## **REMARKS/ARGUMENTS**

### **Amendments to the Drawings:**

**Fig 4**

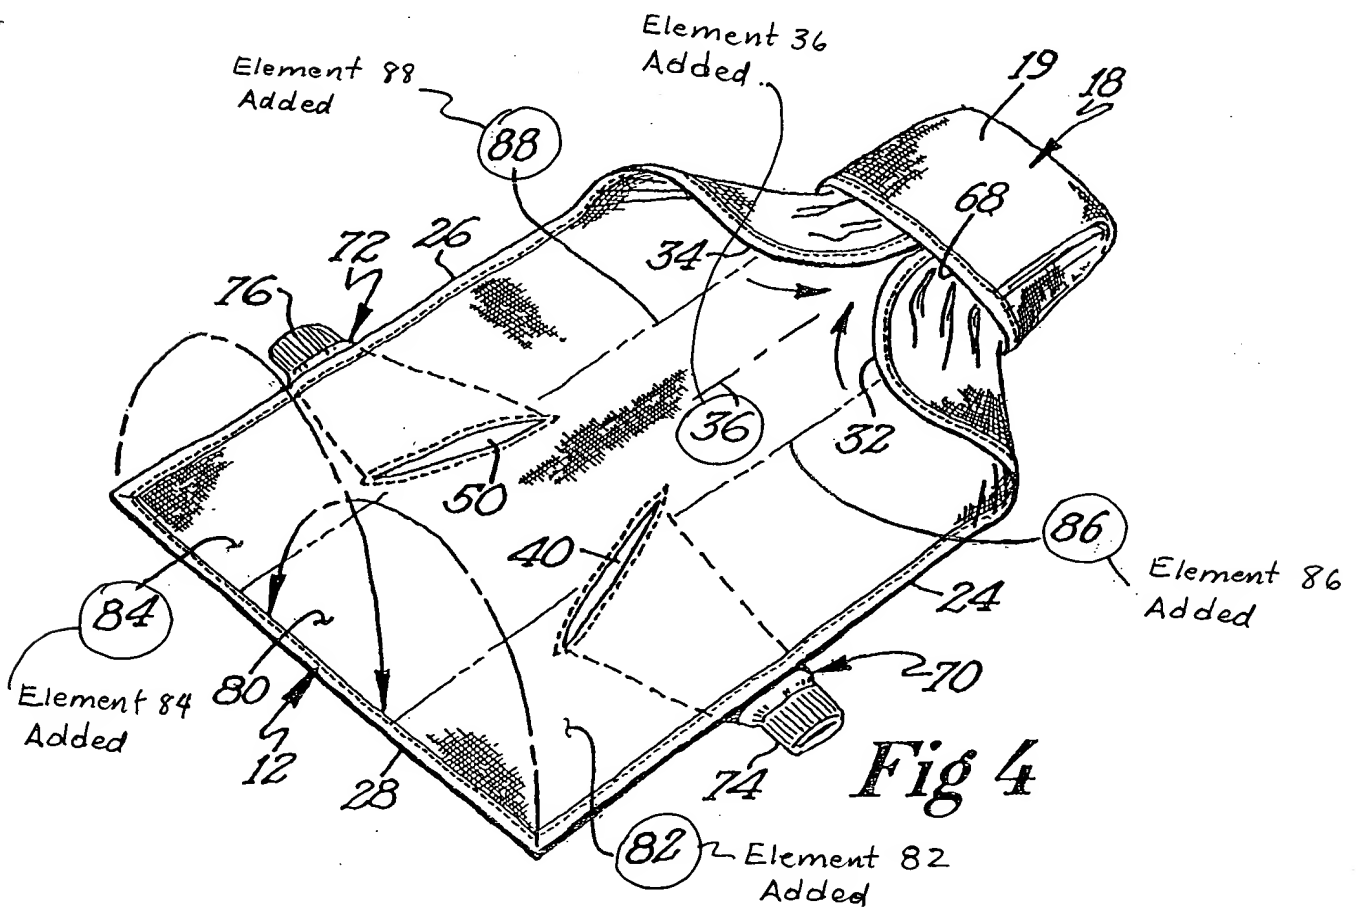
The attached sheet of drawings includes changes to Figure 4. The sheet, which includes Figures 3 and 4, replaces the original sheet including Figures 3 and 4. In Figure 4, elements 36, 82, 84, 86, and 88 have been added.
